AGENDA
DESIGN COMMISSION
Community Room, 3rd Floor
Arlington Heights Village Hall, 33 S. Arlington Heights Rd.
Arlington Heights, IL 60005
April 28, 2026
6:30 PM

REPORT OF PROCEEDINGS OF A MEETING
BEFORE THE VILLAGE OF ARLINGTON HEIGHTS
DESIGN COMMISSION

RE: 16 EAST EUCLID AVENUE - DC #25-102 - SF/TEARDOWN
(CONTINUED FROM 3/24/26)

Re: Metropolis Ballroom (6 S. Vail Avenue); Resubmittal Response to Staff Comments
(Awnings & Signage)

PROP. ARCH
SITE PLAN

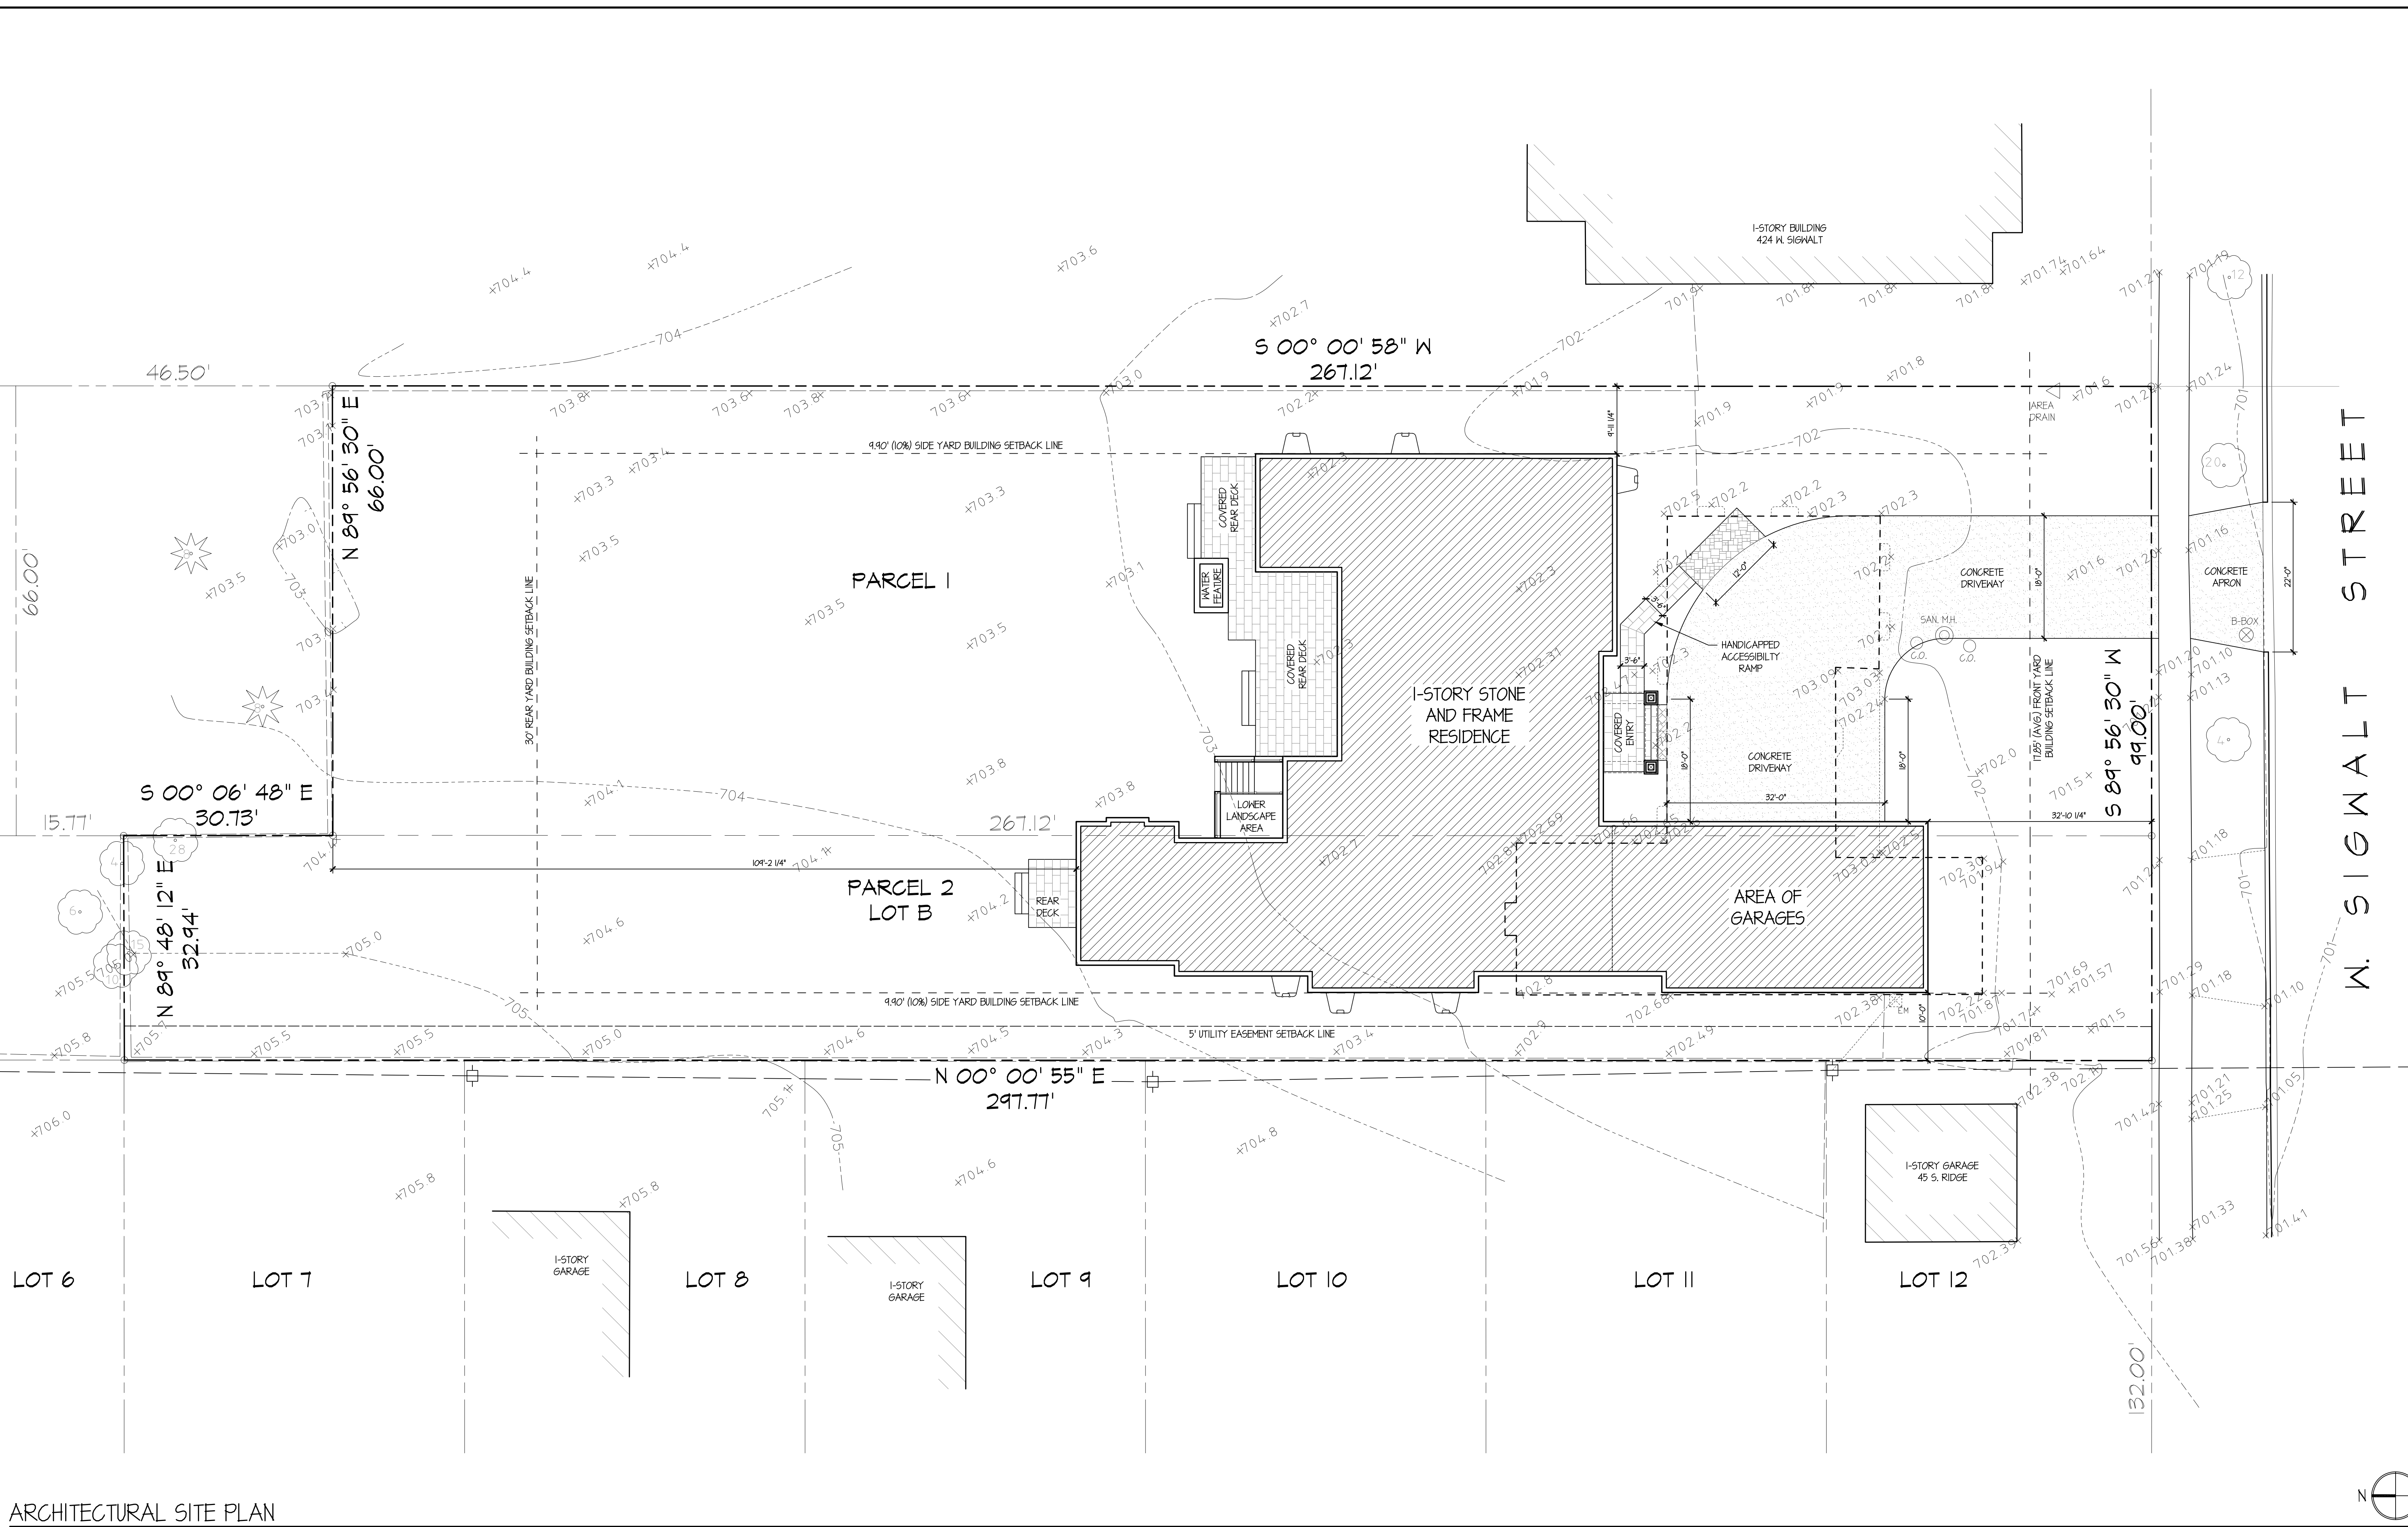
2. Consider a revised layout where the main body of the house is located at the front setback line with a two-car side load garage on the side of the house combined with a front facing recessed one-car garage.

**STAFF PLAN -
RECOMMENDED**

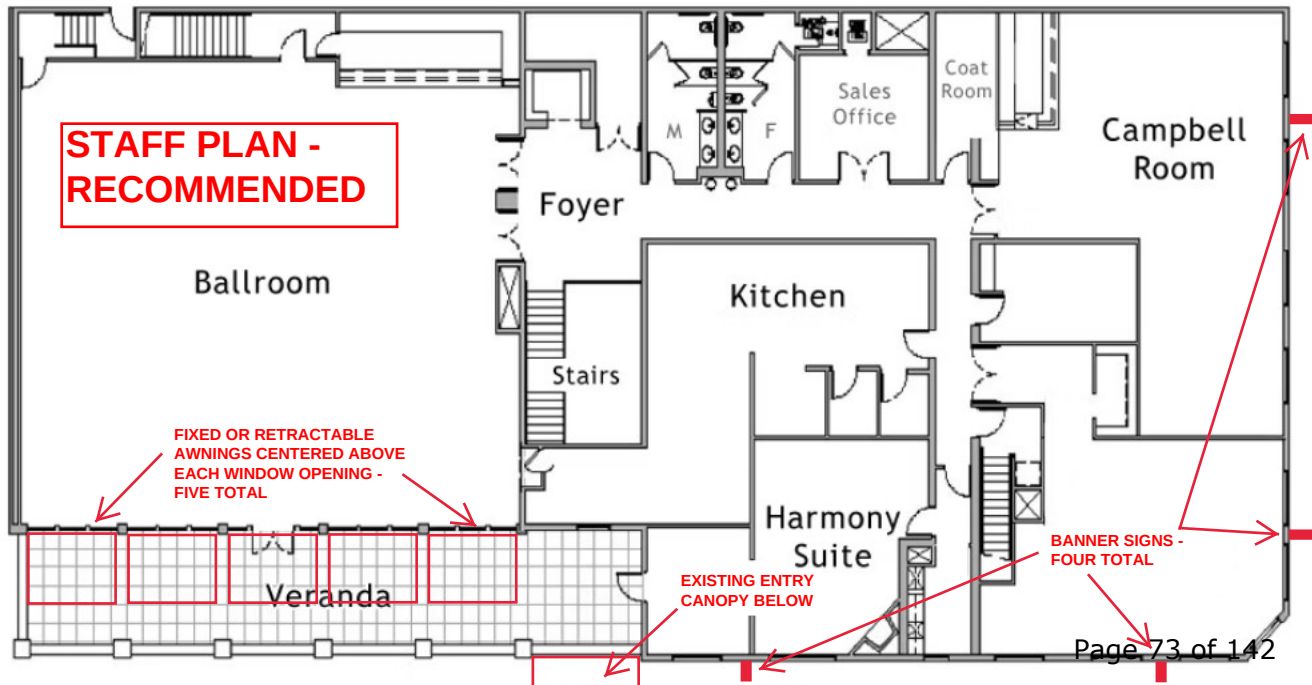
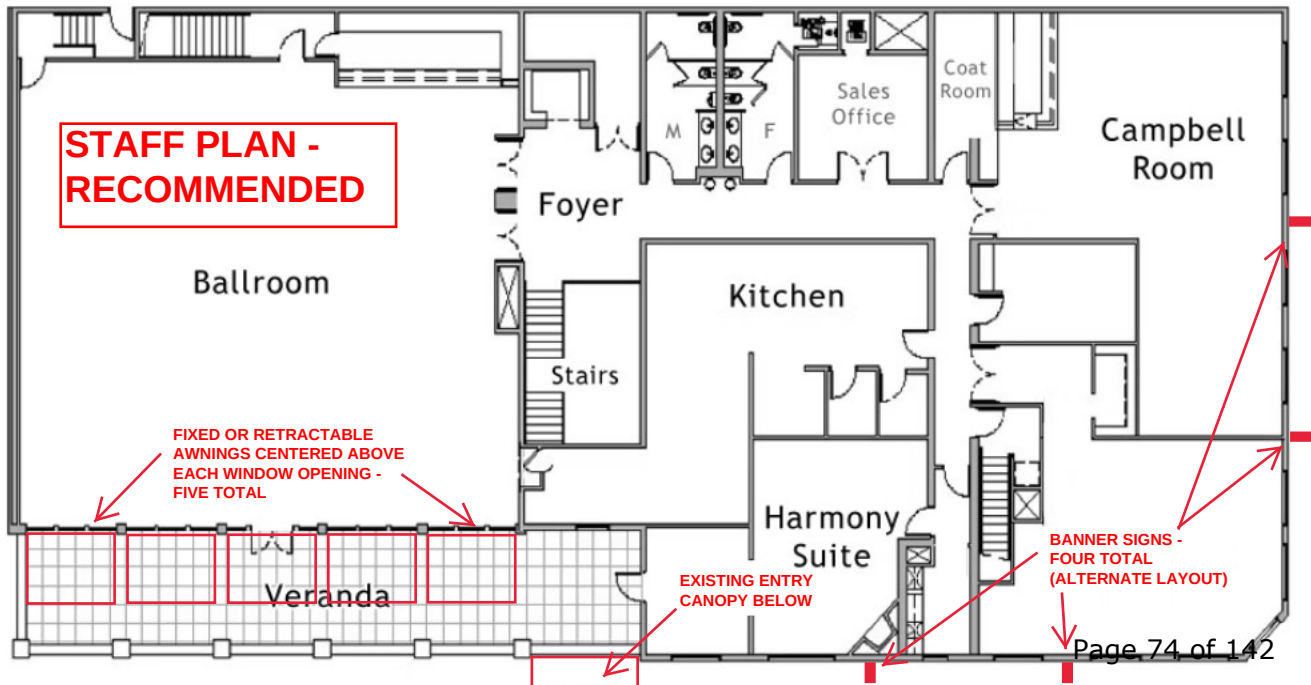
- We understand Staff’s recommendation to revise the layout to six (6) awnings aligned with the windows. After reviewing the functional requirements and vendor constraints, we are proposing four (4) wider retractable awnings to meet the veranda coverage need (approximately 13 feet of depth) and to maintain a clean, cohesive appearance.
- When extended, the retractable awnings open at approximately a 105-degree slope. Because the veranda is located on the second floor, the awnings in the open position will visually block most of the window alignment from a first-floor street view. As shown in the attached renderings (open and retracted), the four-awning configuration does not negatively affect the architectural integrity of the façade; on the contrary, it simplifies the overall appearance by reducing visual segmentation while providing the required functional coverage.

**PROPOSED NEW BLUE
FABRIC ON EXISTING
CANOPY FRAME**

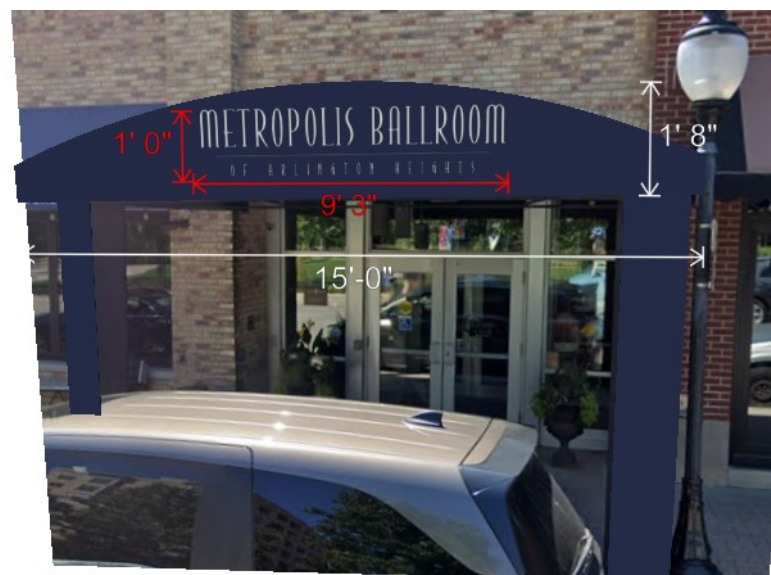
Entrance Canopy. Staff has no objection to the proposal to replace the existing black fabric with new blue fabric.

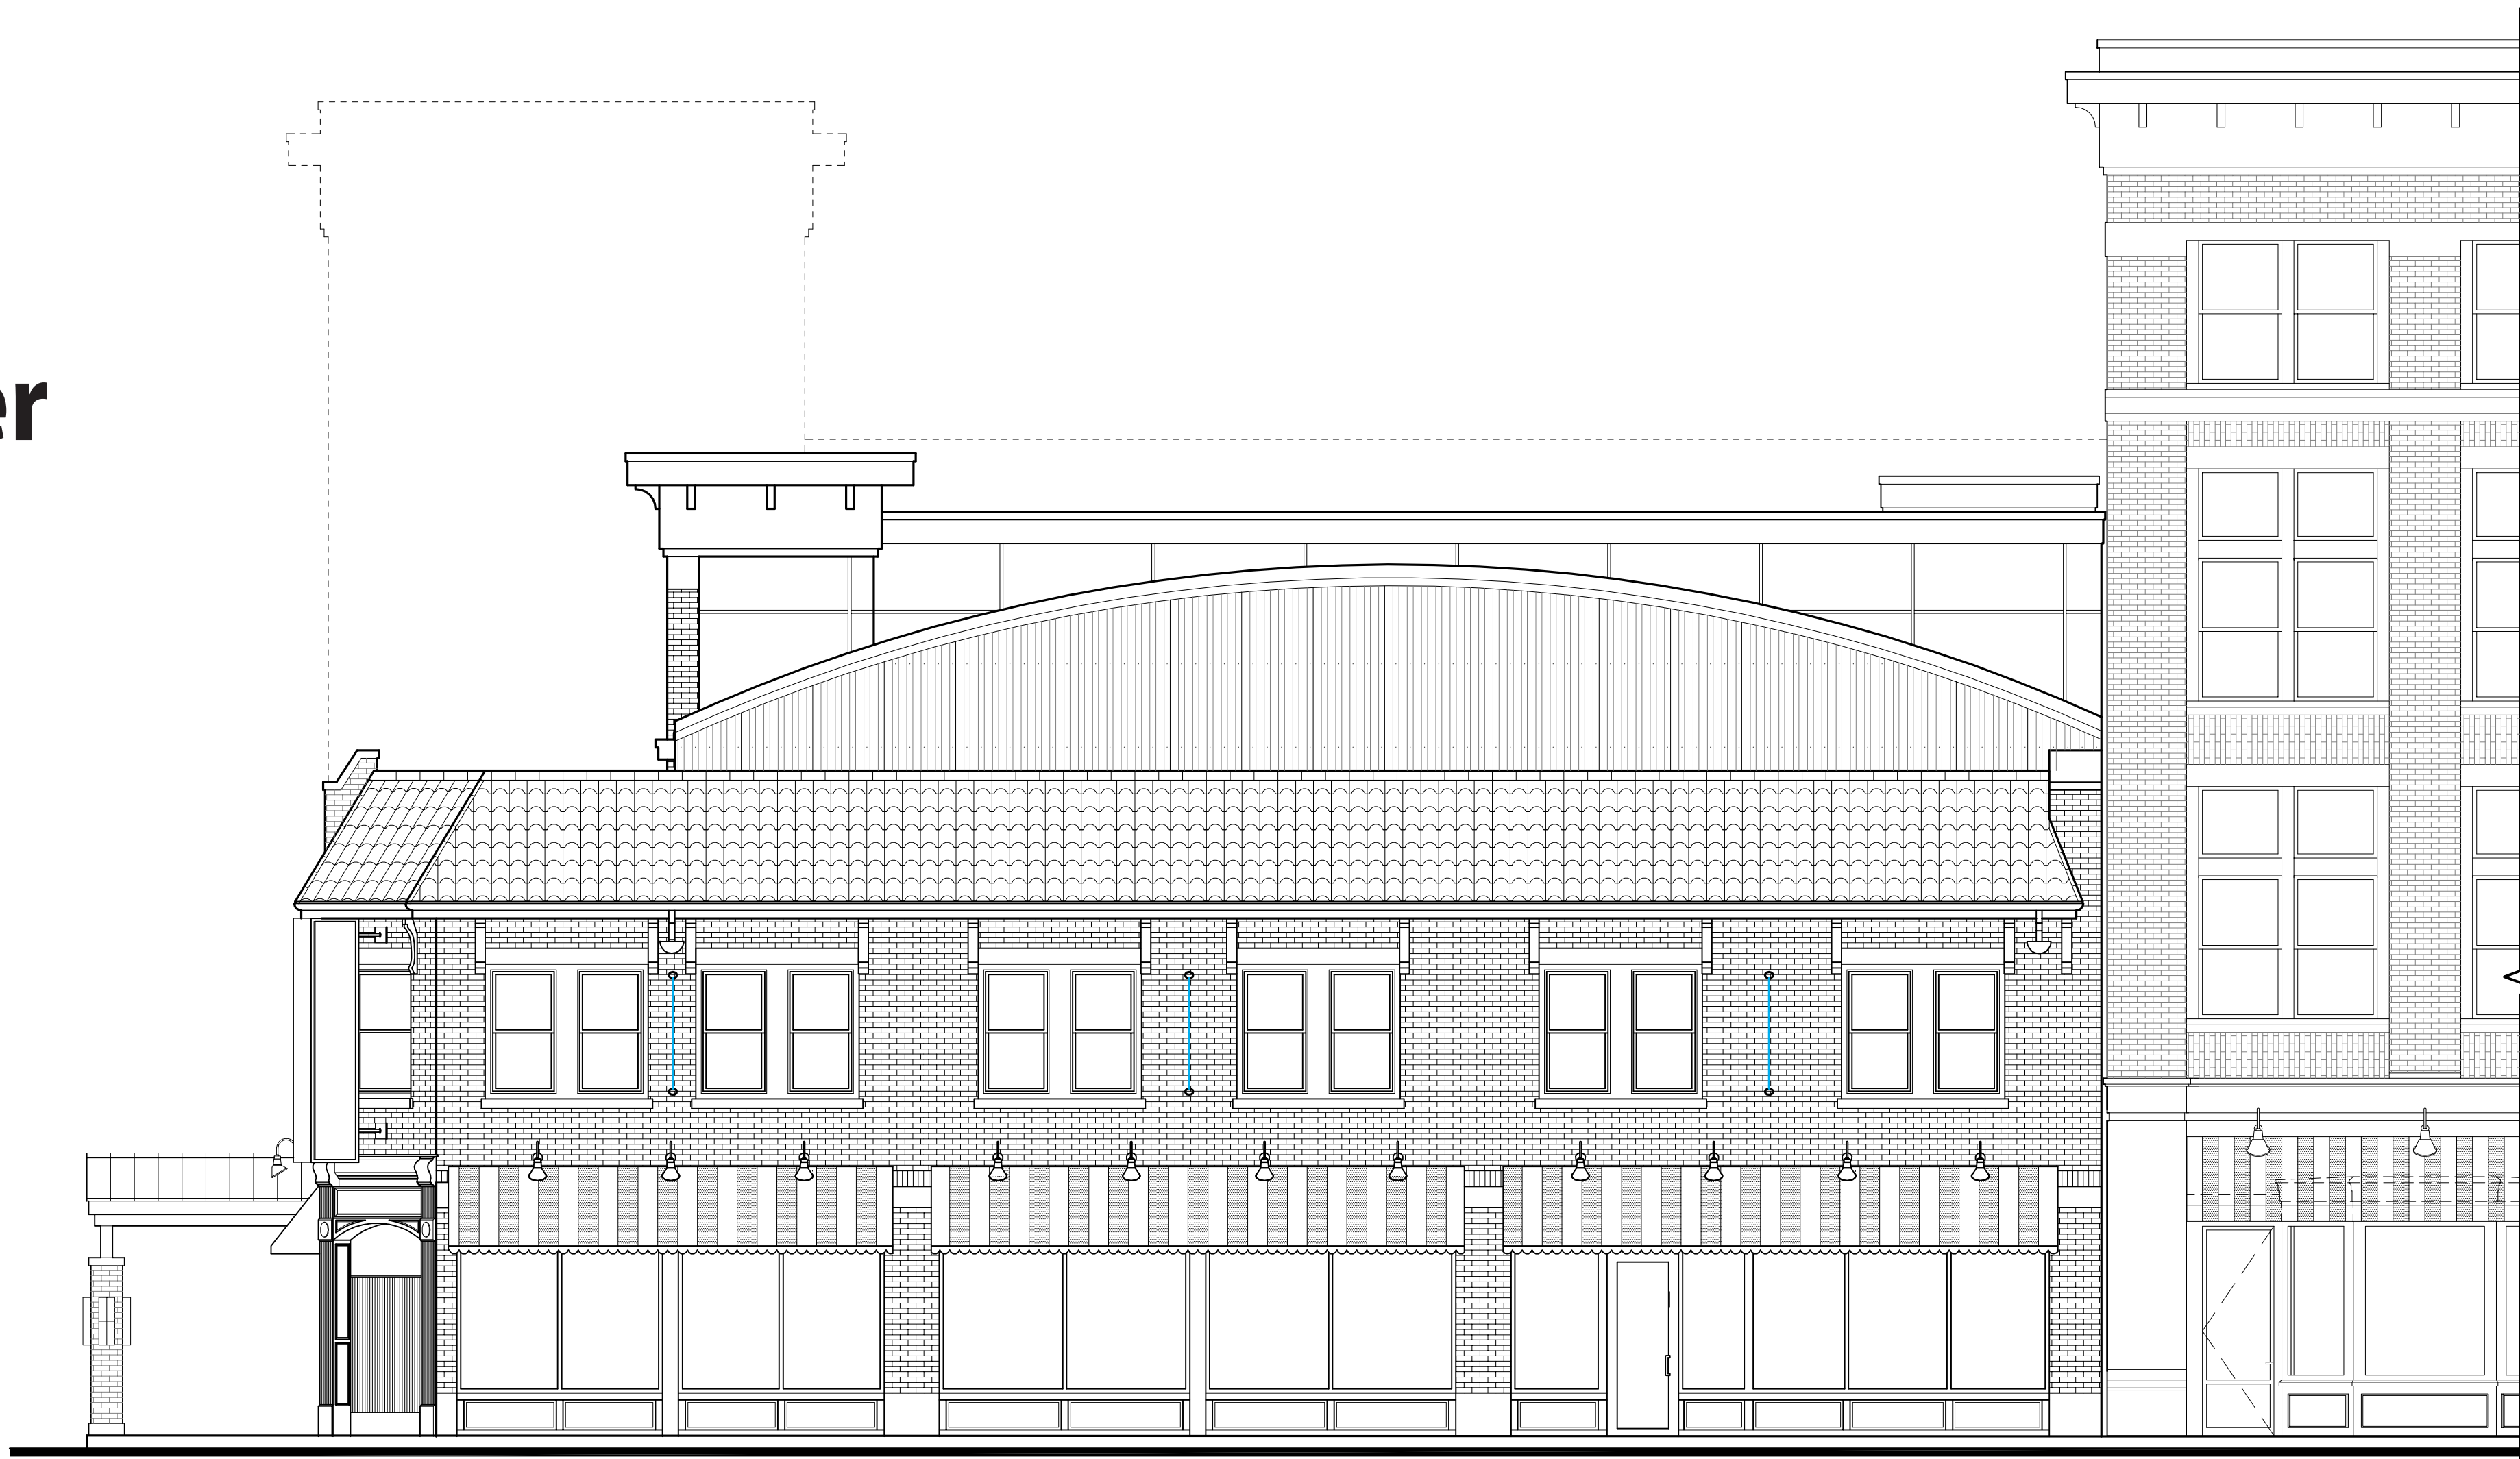
Wall-mounted Banners. Overall, Staff commends the petitioner's effort to come up with a creative sign proposal that looks nice and works well with the existing building design. However, Staff questions the need for six banners, which looks somewhat excessive and busy. The proposed banners are similar to blade signs, which per code are limited to one per street frontage and six sf maximum size each. Considering the unique signage challenge with drawing attention to the second floor, Staff recommends and would support a total of four banners, with two facing each street, but Staff cannot justify the need for six banners.

- We understand that the wall-mounted banner signs require a Sign Variation and Village Board approval process. We will proceed with the separate Sign Variation application as required.
- The attached documents clarify the banner size, proportions, mounting approach, and placement.
